**SOLICITATION AMENDMENT  
MODIFICATION DE L'INVITATION**

<b>Title - Sujet</b> LBP Security Upgrades - Constructio	
<b>Solicitation No. - N° de l'invitation</b> EP916-182156/A	<b>Amendment No. - N° modif.</b> 019
<b>Client Reference No. - N° de référence du client</b> 20182156	<b>Date</b> 2018-06-22
<b>GETS Reference No. - N° de référence de SEAG</b> PW-\$\$\$FG-362-74724	
<b>File No. - N° de dossier</b> fg362.EP916-182156	<b>CCC No./N° CCC - FMS No./N° VME</b>
<b>Solicitation Closes - L'invitation prend fin</b> <b>at - à 02:00 PM</b> <b>on - le 2018-06-28</b>	
<b>Time Zone</b> <b>Fuseau horaire</b> Eastern Daylight Saving Time EDT	
<b>F.O.B. - F.A.B.</b> <b>Plant-Usine:</b> <input type="checkbox"/> <b>Destination:</b> <input checked="" type="checkbox"/> <b>Other-Autre:</b> <input type="checkbox"/>	
<b>Address Enquiries to: - Adresser toutes questions à:</b> Kelly, Jessica	<b>Buyer Id - Id de l'acheteur</b> fg362
<b>Telephone No. - N° de téléphone</b> ( ) - ( )	<b>FAX No. - N° de FAX</b> ( ) -

## **ADDENDUM 014**

## **ADDENDUM 015**

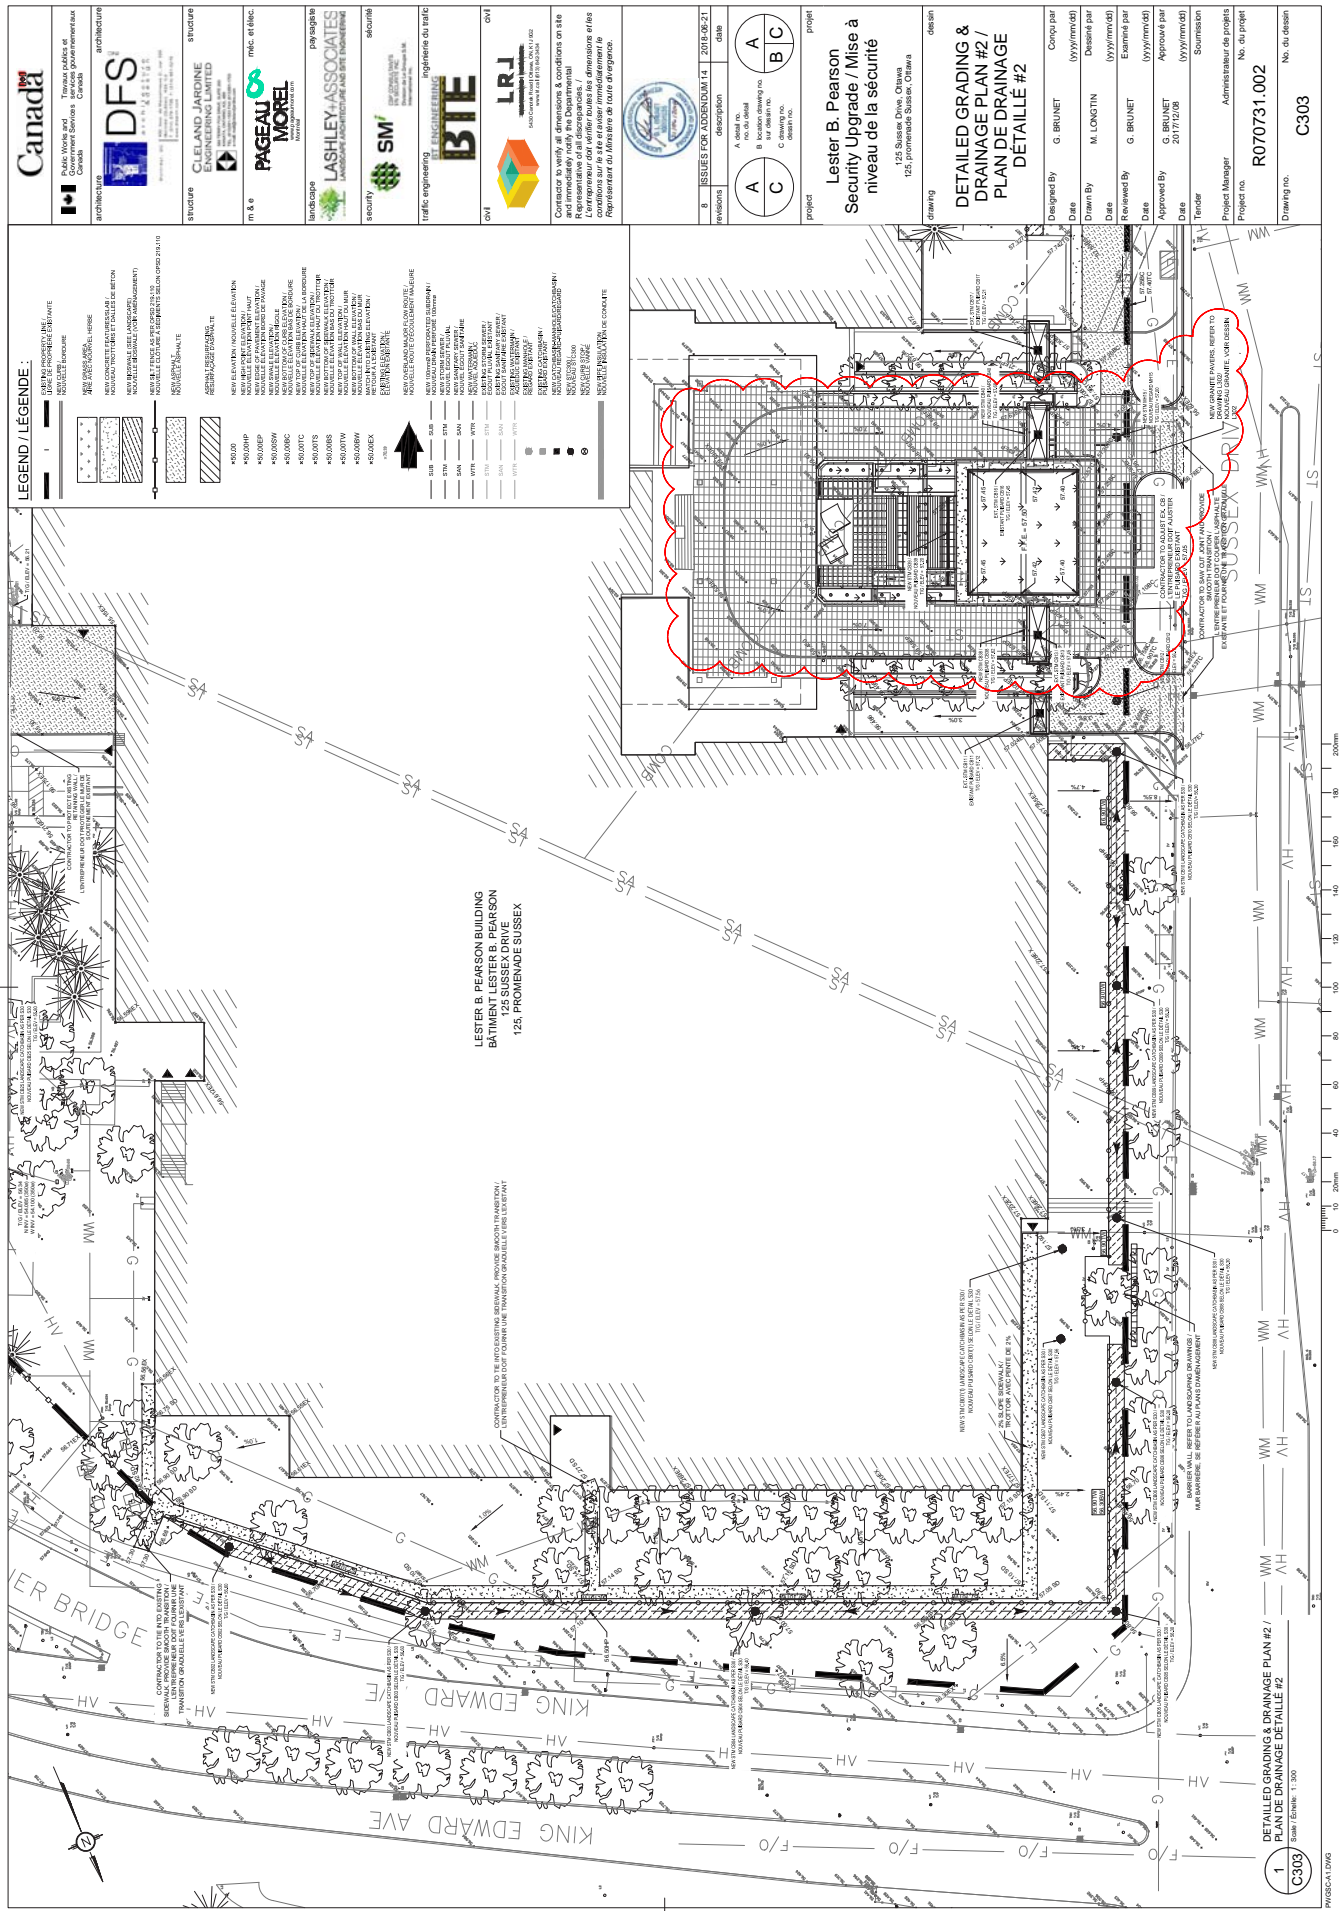
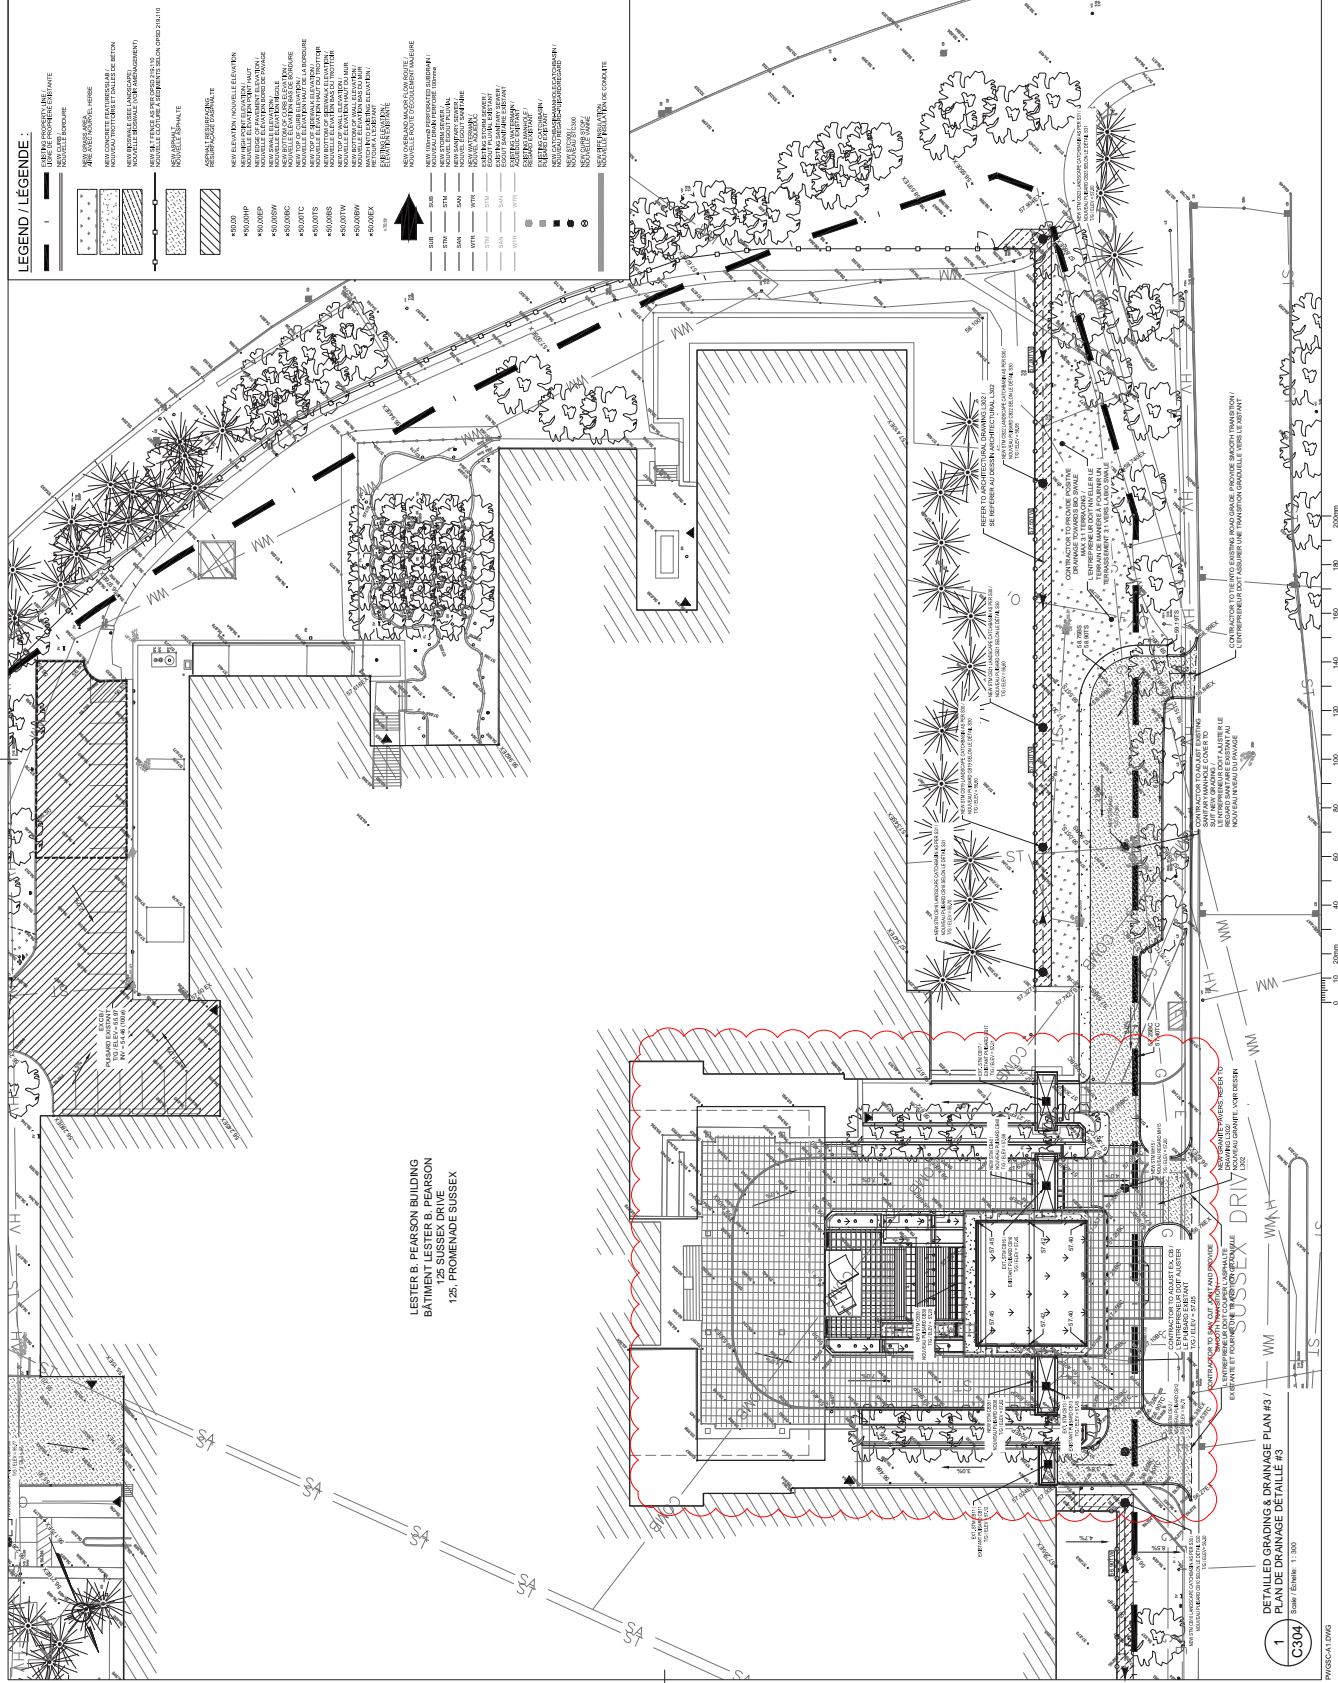
Drawing C303 rev.7 and C304 rev.7 show the asphalt up to the main entrance with pavers directly in front, and yet the landscape drawing L101e Addendum 008 shows that the granite pavers wrap around the front of the building within the drive lanes. Which drawing are we to follow as these are completely different.

- .1 C303-DETAILED GRADING & DRAINAGE PLAN #2 / PLAN DE DRAINAGE DÉTAILLÉ #2; refer to attached drawing C303.
  - .1 Drawing has been revised to clarify the extent of granite pavers.
- .2 C304-DETAILED GRADING & DRAINAGE PLAN #2 / PLAN DE DRAINAGE DÉTAILLÉ #2; refer to attached drawing C304.
  - .1 Drawing has been revised to clarify the extent of granite pavers.

Please refer to Addendum No.014

SITE PLAN / PLAN DE L'IMPLANTATION

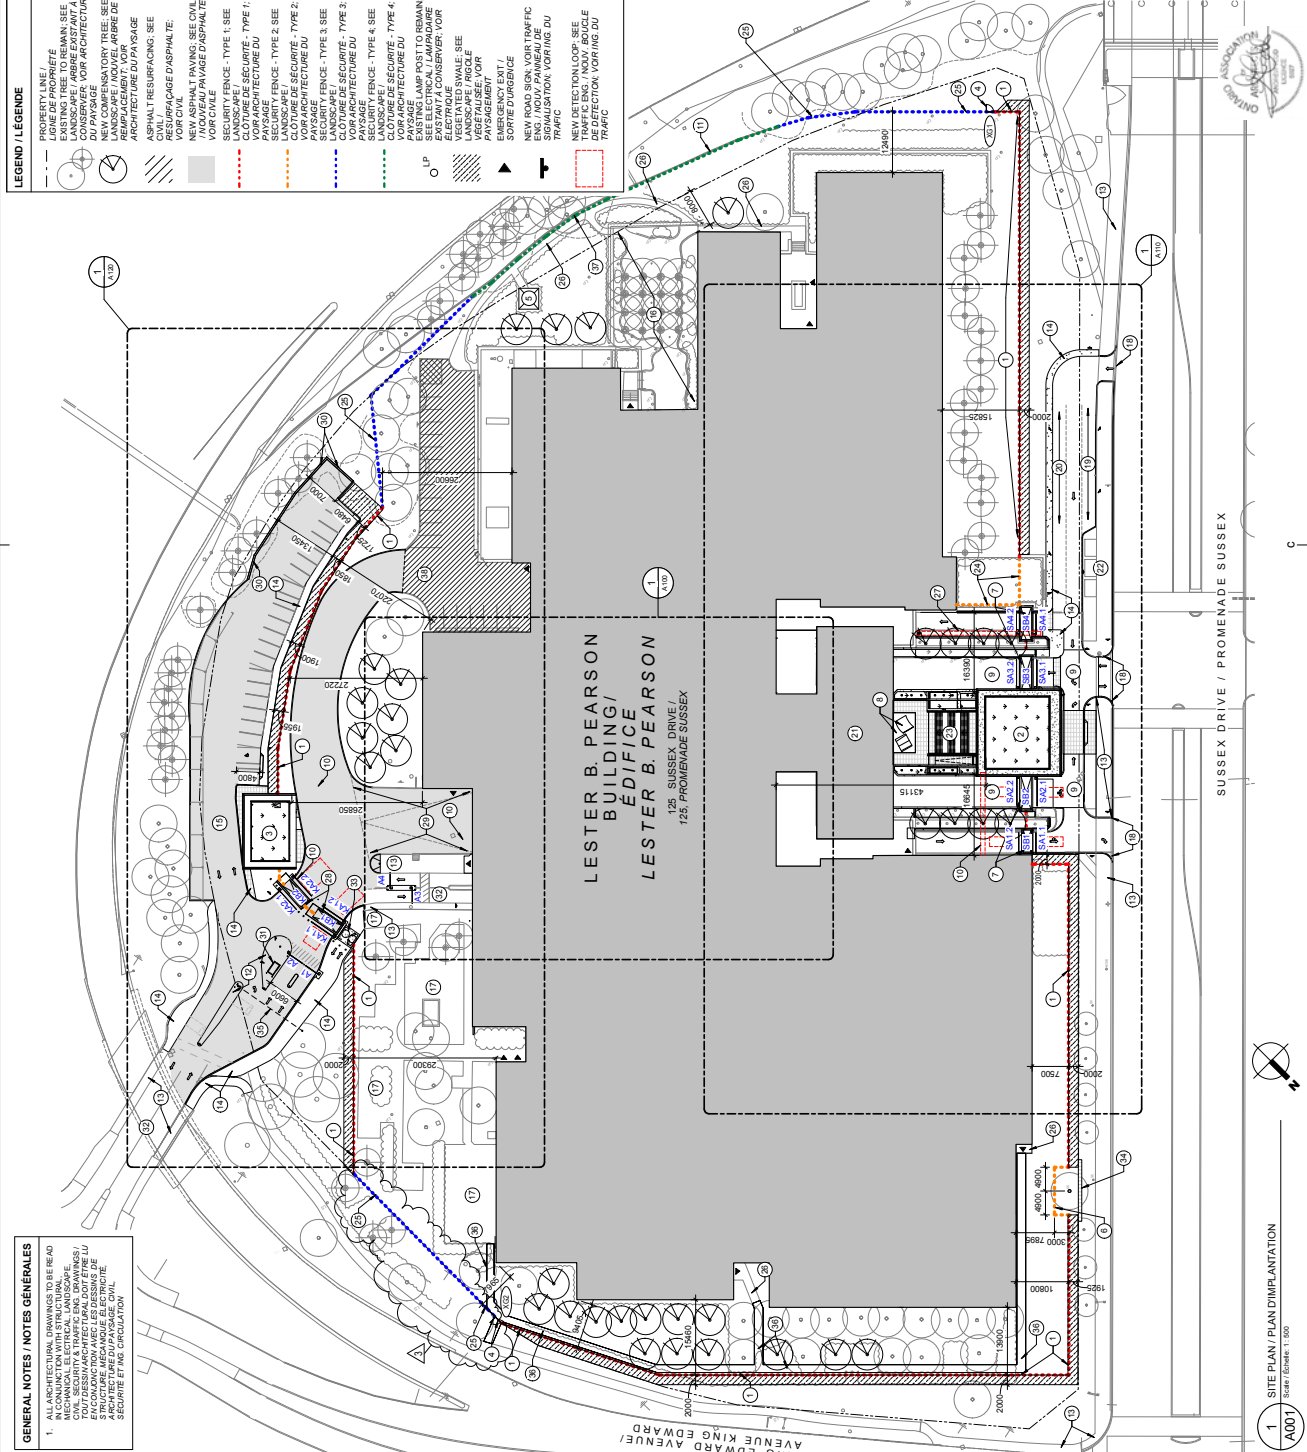
Please provide clarification: There is a ~42m section of fence that is called up as Type 3 Fence on Landscape Drawings – i.e. L101e and is called up as Type 2 Fence on Architectural Drawings i.e. A003. Which type of fence is required in that area?

- .1 A001- SITE PLAN / PLAN DE L'IMPLANTATION; refer to attached drawing A001.
- .1 Drawing has been revised to clarify the type of security fence required at the perimeter security fence access gate XG2.

Please refer to Addendum No.015
